FIELD SERVICE CAMPAIGN – 21112

Grid Heater Relay

Certain International® MV™ Series and DuraStar® models with Cummins® ISB engines only.

The grid heater relay may stick closed resulting in battery draw.

Figure 3. Grid Heater Relay New Orientation

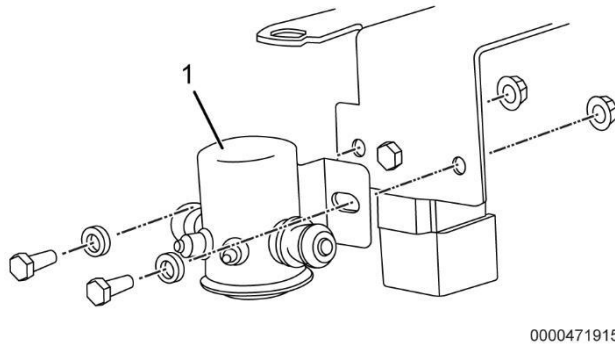
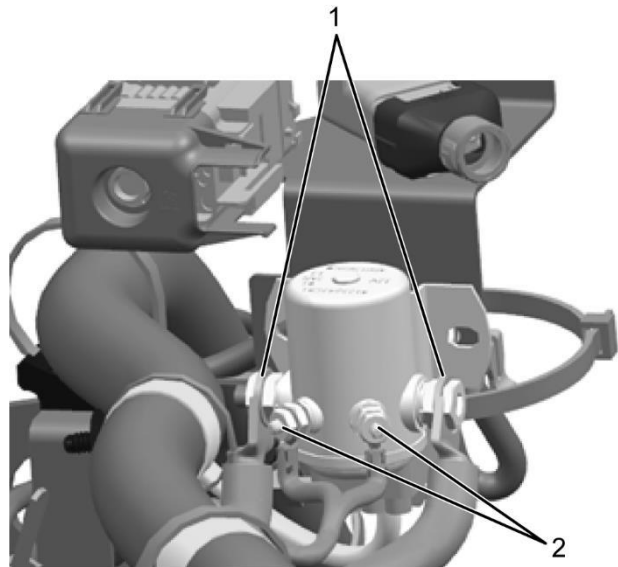
1. Grid heater relay
9. Rotate new grid heater relay 180 degrees (Figure 3, Item 1) from original orientation and install. Install bolts (Figure 2, Item 1), washers (Figure 2, Item 2), and nuts (Figure 2, Item 3). Using torque wrench, tighten nuts and bolts to 115 lb-in (13 N•m).

Figure 3, Any Movement of The Terminal Back and Forth As Shown is Unacceptable.

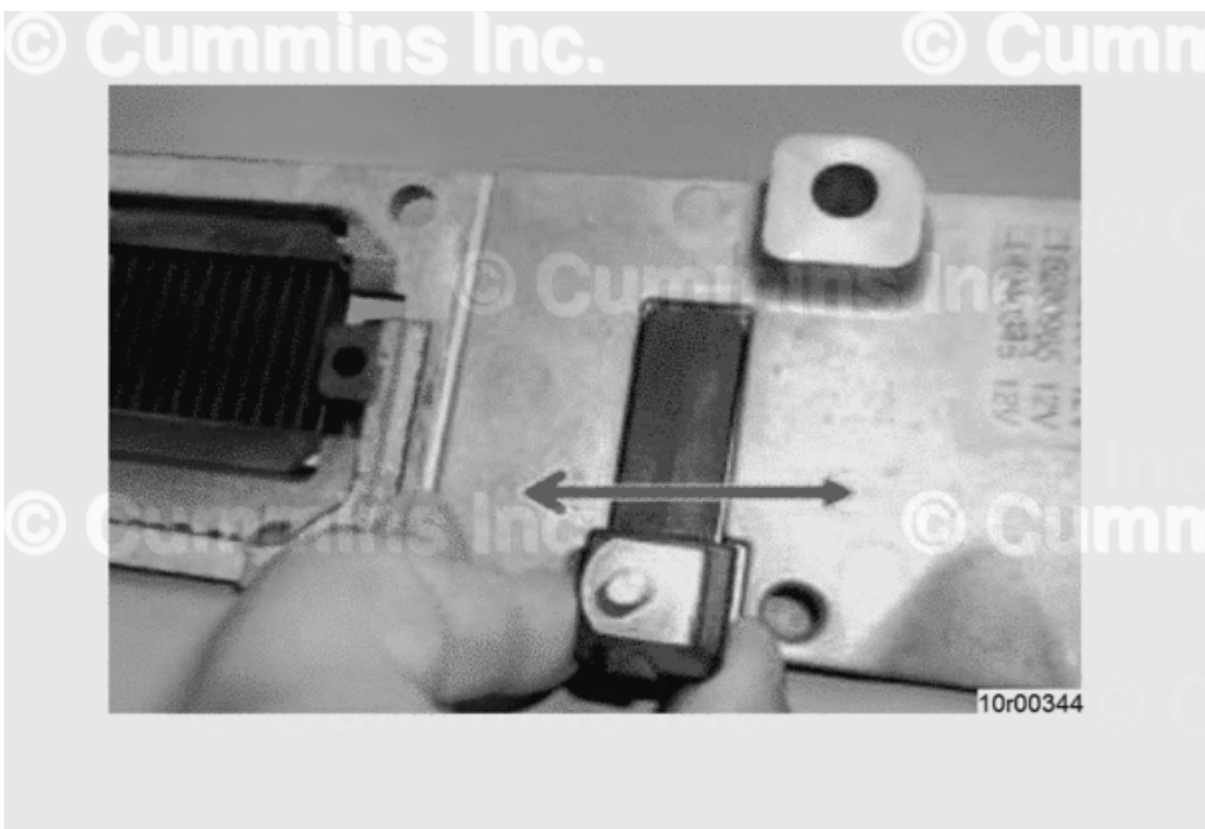
- Intake air heater relay stuck closed leading to extended on-time of the heater. Units experiencing Fault Code 383 may have experienced extended on-time of the intake air heater with no air flow entering the system caused by a stuck relay, causing the air heater to overheat. The isolated power connection bar may expand and lift from the top surface of the intake manifold cover due to extended on-time (Figure 1). The isolated power connection bar may also become loose. The issue may progress and exhibit electrical arcing damage to the intake air heater internal joints (Figure 2), with potential for arcing to cause debris to drop into the intake system.

- Inspect the insulated power connection bar for deformation. See Figure 1 below. Removal of the intake manifold cover is **not** necessary to inspect the insulated power connection bar.
- Check if the intake air heater power terminal can be moved by hand. See Figure 3 below.

- Intake air heater damage that exhibits power connection bar deformation or movement of the terminal back and forth is due to intake air heater relay failure and is **not** covered under Cummins ® warranty. Repair locations are to contact the OEM for further repair direction.
- For Navistar® and IC Bus applications reference iKnow article IK1201457.
